**SUBJECT:** Tentative approval of the request of Toll Brothers LLC for development of Covington Estates, JSP 21-47 as a Residential Unit Development (RUD) and approval of the RUD Plan. The subject property is located on 54.3 acres in Section 31, north of Eight Mile Road and west of Garfield Road in the RA, Residential Acreage District. The applicant is proposing a 44-unit single-family development. The approval would be subject to entry into an RUD Agreement between the City and the applicant.

# JSP21-47 COVINGTON ESTATES RUD

# PLAN REVIEW CENTER REPORT

RUD Concept Plan

TOLL BROTHERS  
COVINGTON ESTATES  
RESIDENTIAL UNIT DEVELOPMENT PLAN  
UTILITY PLAN

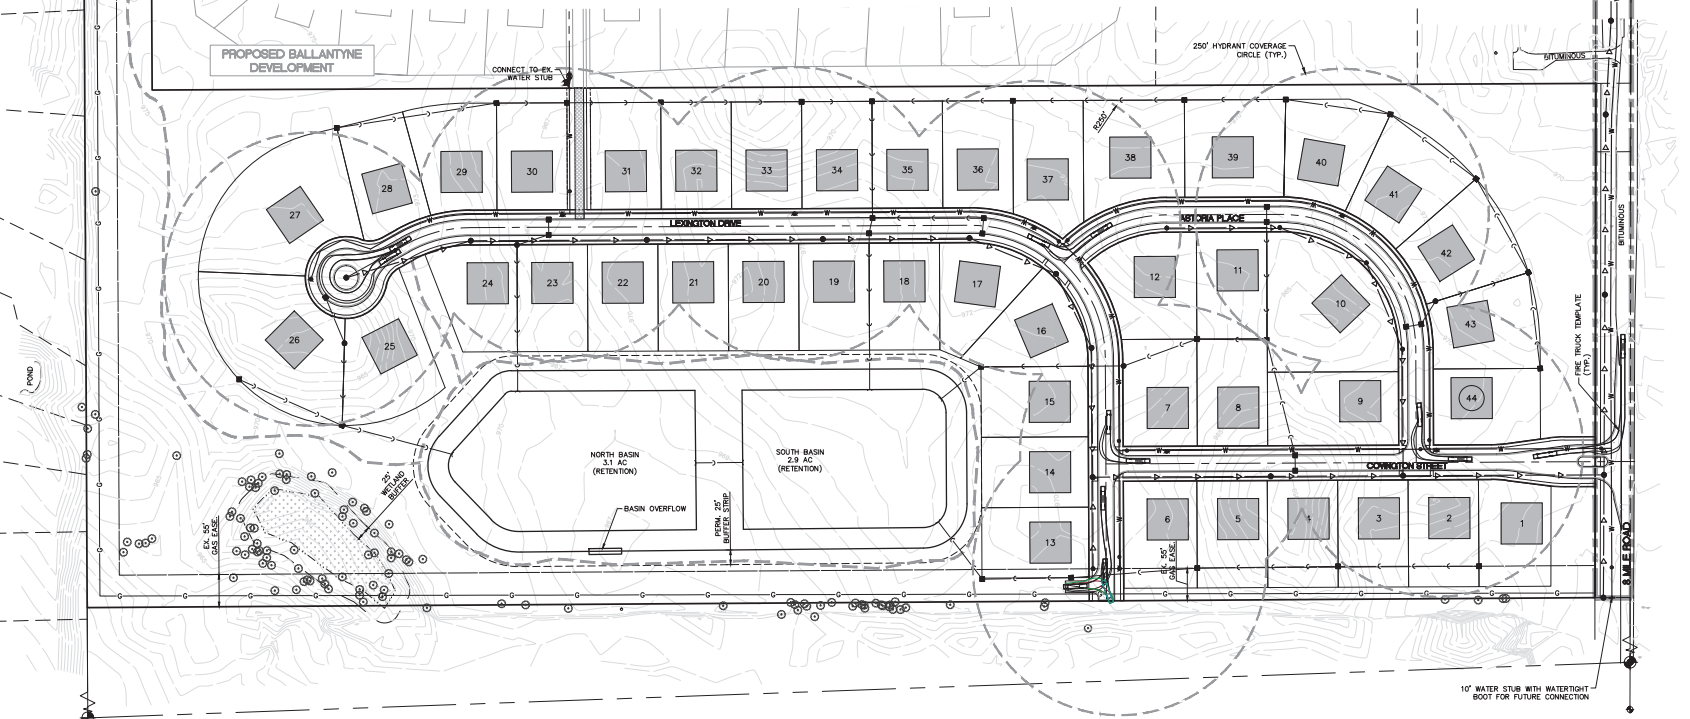
**The applicant has provided a written statement, however it is not clear how the open space to be preserved will be permanently protected. Will an Open Space Preservation Easement be granted? In addition, Sheet 6 of the plan set indicates 3.2 persons per unit for a total population of 141 persons, while the narrative indicates a total population of 176 people. Please clarify the inconsistency.**

5. RUD Intent - The applicant has provided a written statement, however it is not clear how the open space to be preserved will be permanently protected. Will an Open Space Preservation Easement be granted? In addition, Sheet 6 of the plan set indicates 3.2 persons per unit for a total population of 141 persons, while the narrative indicates a total population of 176 people. Please clarify the inconsistency.

**Response:** *Refer to the response to planning comment #1 with regard to the open space preservation. The total population of 141 persons is the correct population (as depicted in the Sanitary Basis of Design on Sheet 6).*

**Response:** *The sanitary basis of design using the requested peaking factors is shown on Sheet 6 of the preliminary RUD plans.*
25. Note on the construction materials table that 6-inch sanitary leads shall be a minimum SDR 23.5, and mains shall be SDR 26.

**PERFORATED RISER**  
NO SCALE

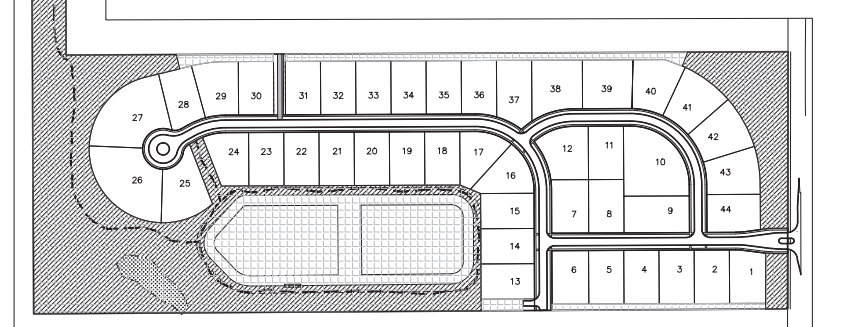
48. Remove perforated riser detail from sheet 10.  
**Response:** *This detail will be removed on subsequent plan submittals.*
49. Design construction standards state that ponds (basins) shall be designed as an integral part of the overall site plan and shall be considered a natural landscape feature having an irregular shape. It is recommended that the basin have a more natural shape.
